From: Andrew Leon
Sent: Tuesday, February 21, 2023 8:25 AM
To: Ryan Harriman
Subject: FW: Totally Against DSR22-014 Baskin Robbins Proposed 10-unit building

From: Sarah Fletcher <fletchsa1@gmail.com>
Sent: Sunday, February 19, 2023 7:04 PM
To: Andrew Leon <andrew.leon@mercerisland.gov>; Jeff Thomas <jeff.thomas@mercerisland.gov>; Planning Commission <Planning.Commission@mercergov.org>; Design Commission <Design.Commission@mercergov.org>
Subject: Totally Against DSR22-014 Baskin Robbins Proposed 10-unit building

Figure 2— Area of Required Retail, Restaurant or Personal Services Use Along Ground Floor Street

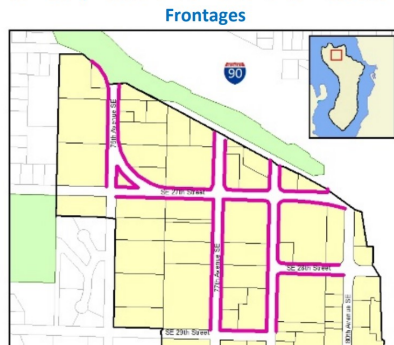
And it has where **RETAIL IS REQUIRED**, but the proposed building is not offering any retail. See map below:

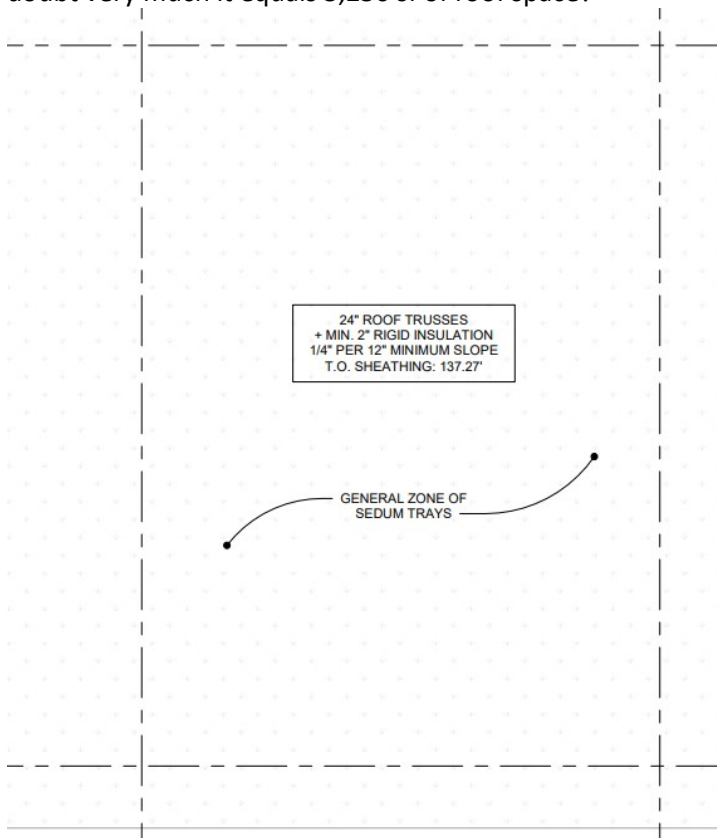
It says that 3,250 sf of sedum trays on the roof, but if you look at the plans on page 7, it does not show 3,250 sf of sedum trays, it shows a portion. And are you trying to say, that they can go across the road, buy a few trays of sedum and put them on the roof, and that is sufficient?

As I am a layman and don't know how to read plans, how much exactly is it showing? I

a) And what happens if the greenery dies?

If you look at the plans, it has a section of the roof as for the sedum trays on a portion and not even on the whole roof, I doubt very much it equals 3,250 sf of roof space?

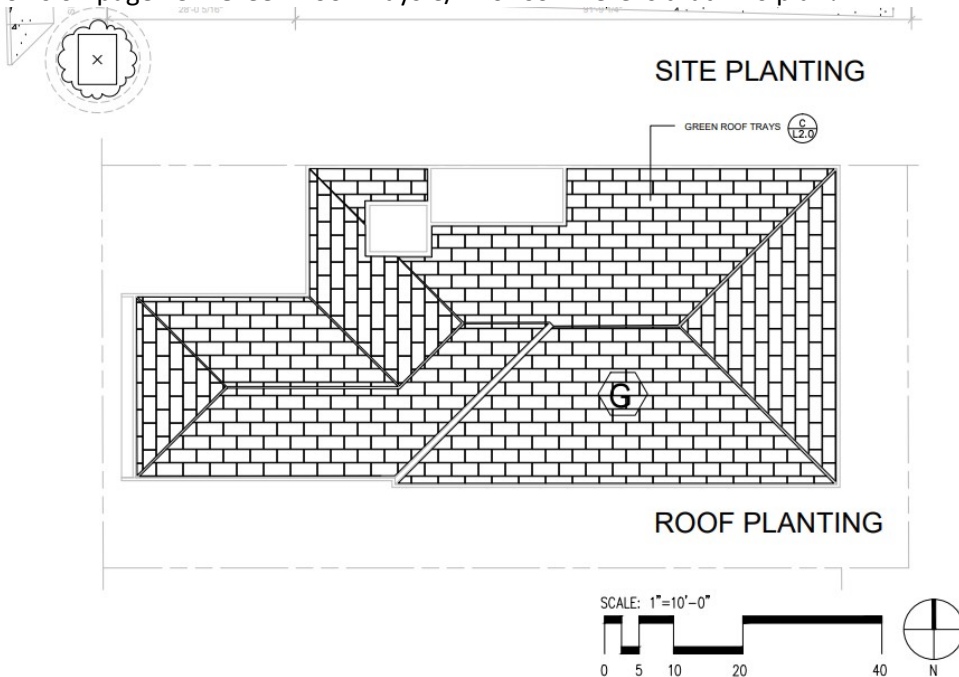
Hello, what exactly does the architect mean by "shared garage parking?" Is this allowed per the Code and if not, what is not allowed exactly? They plan on having one vehicle per unit, one ADA van parking space, who exactly are they planning on sharing the parking bays with and if it is QFC, does QFC know and is there an agreement in place with QFC to share the parking with them? I will let people know on Nextdoor.

Landscaping

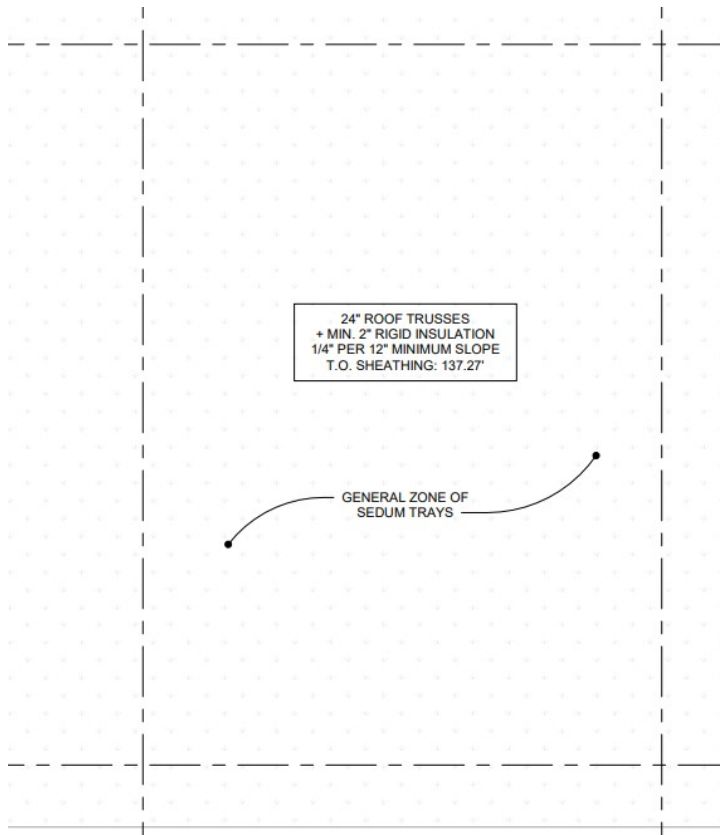
It says that 3,250 sf of sedum trays on the roof, but if you look at the plans on page 7, it does not show 3,250 sf of sedum trays, it shows a portion. And are you trying to say, that they can go across the road, buy a few trays of sedum and put them on the roof, and that is sufficient?

As I am a layman and don't know how to read plans, how much exactly is it showing? I

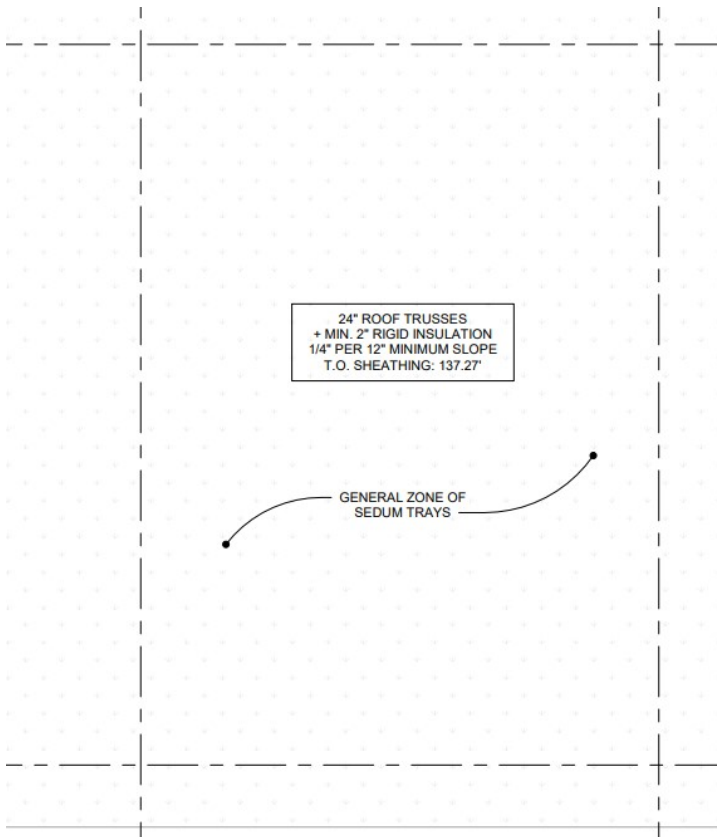
It says that 3,250 sf of sedum trays on the roof, but if you look at the plans on page 7, it does not show 3,250 sf of sedum trays, it shows a portion. And are you trying to say, that they can go across the road, buy a few trays of sedum and put them on the roof, and that is sufficient?

As I am a layman and don't know how to read plans, how much exactly is it showing? I

a) And what happens if the greenery dies?
